# SERVICE INFO

## Visual differences in belt tensioner 533 0086 30

533 0086 30

**Image 1:** INA design with two M8x35 bolts

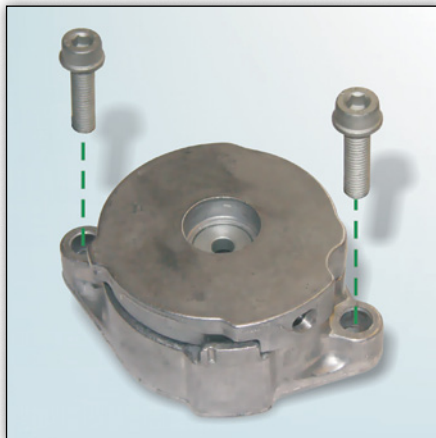
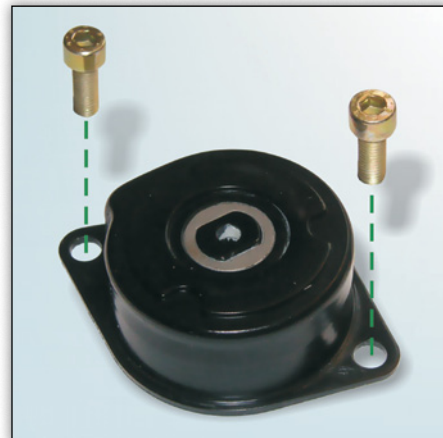
When replacing the belt tensioner 533 0086 30, the versions shown can be installed on the vehicle. Schaeffler Automotive Aftermarket currently offers the version shown in Image 1.

Both versions conform to technical requirements.

The bolts (M8x35) supplied by Schaeffler Automotive Aftermarket must be used due to the greater flange thickness of the belt tensioner 533 0086 30 (Image 1).
